## SERVIS BULLETIN No. BB/51

1. WITH REFERENCE TO: All hot-air balloons Kubicek and Aerotechnik operated with Ignis 2-

2. REASON: Weld crack of suspension of Ignis 2-units burner

$\label{eq:enclosure 1} Enclosure \ 1 \\ \textbf{Example of a weld crack of suspension of Ignis 2-units burner}$

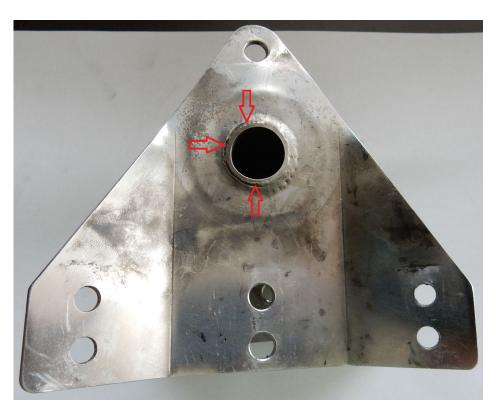
Example see below - Enclosure 1

**3. REQUIRED ACTION:** Replacement of suspension of the burner units

**7. NECESSARY MATERIAL:** New burner suspension, part number.: 53128.00

8. PROCESS: Replace the burner suspension. Follow the instructions given in appropriate
